Expansion of National Ceramic Industries Australia Facility, Rutherford NSW Environmental Assessment

Submissions Report

2 November 2010

Figure 1: NCIA Background and Measured PM₁₀ Concentrations, Plotted Cumulatively and Contemporaneously

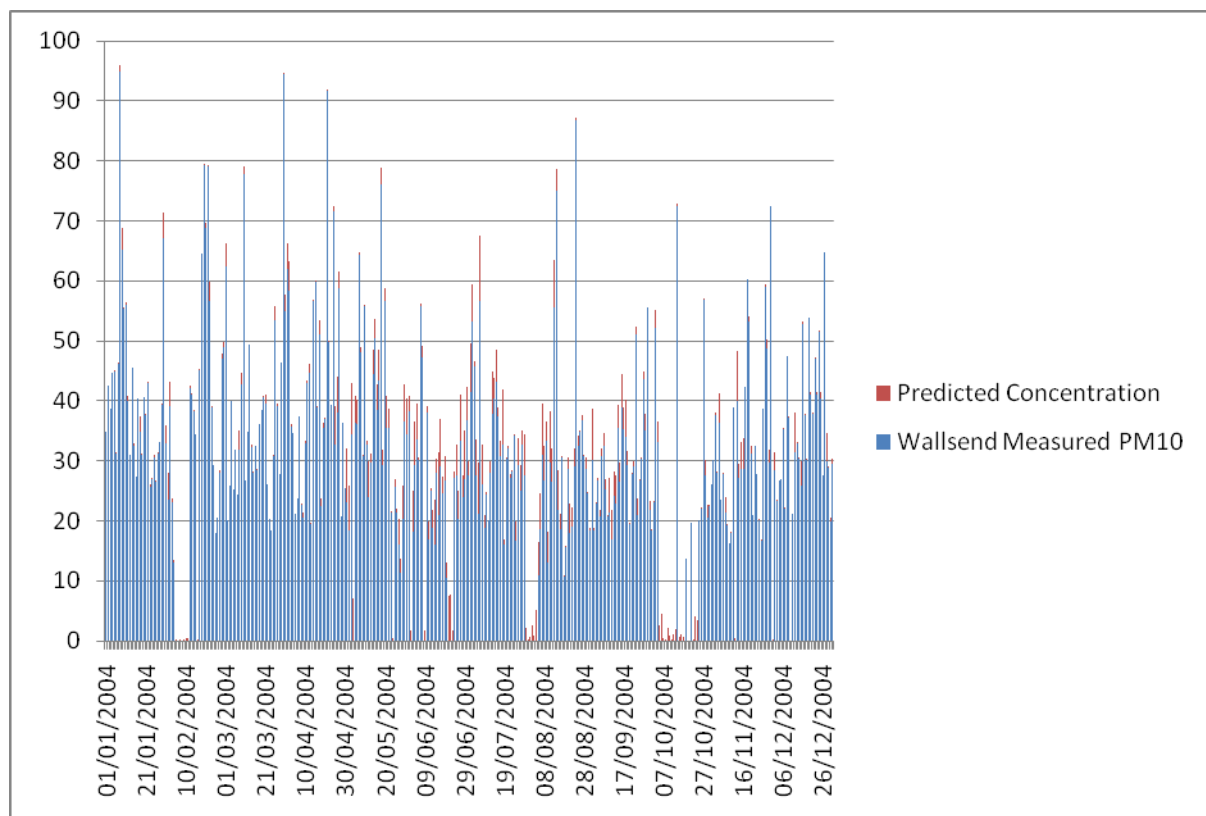
In an effort to ensure that air quality is maintained at least to current levels, Council requests that the Minister prior to the determination of the application, require the applicant to provide a detailed investigation of mitigation measures to reduce particulate stack emissions with a view to limiting PM₁₀ 24hr average GLC exceedances to those under the Scenario 1 modelling.

The cumulative contemporaneous predictions showing the contribution from background has also been plotted and is shown in **Figure 1** and **Figure 2** (for NCIA and Wallsend).

The findings of this study show that the expected influence of the Project is low with between zero and one additional 24 hour average PM₁₀ exceedances expected as a result of the operation of the Project. Given the variability of the background data this slight increase in exceedances is not expected to result in a quantifiable impact on surrounding receptors.

Figure 3: Noise Mitigation Assessment Locations

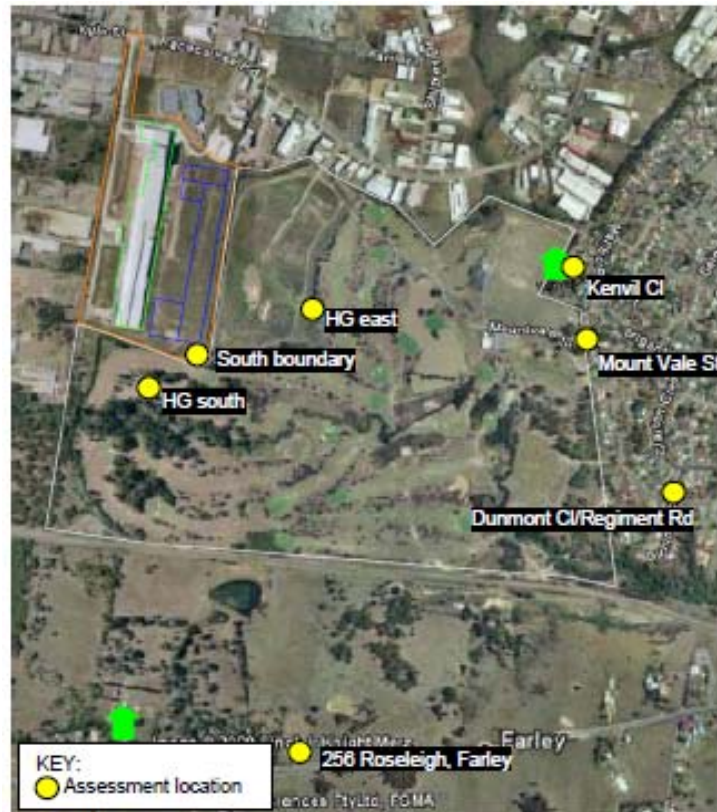
DOP Comment:

- Option 1 - increased thickness of metal sheeting to 0.48 BMT on the east façade, south façade and roof (previous assumption in noise model was 0.3 BMT) with 55 mm insulation fixed to underside of roof;
- Option 2 - south and east facades constructed of two (2) layers of 0.48 BMT metal sheeting with 150 mm cavity insulation. Roof constructed of 0.48 BMT single sheet metal with 55 mm insulation fixed to underside; and
- Option 3 - south and east facades constructed of 100 mm tilt-up concrete panels. Roof constructed of 0.48 mm BMT single sheet metal with 55 mm insulation fixed to underside.

The above mitigation options were assessed to the receiver locations shown in **Figure 3** for calm weather conditions and compared to existing predicted levels from the previous NIA (Appendix E of the EA). Results from the mitigation assessment are provided in **Table 3**.

This is shown in **Table 3** at the HG east receiver (which is closest to this noise source), where only an additional 1 dB(A) overall reduction is achieved from Option 1 to Option 2 and 1.4 dB(A) from Option 1 to Option 3. From an environmental noise perspective, this change in noise level would be considered insignificant as it is commonly stated that a 1 to 2 dB change is typically not discernable to the human ear (NSW EPA, ECRTN, Appendix B, Section 4).
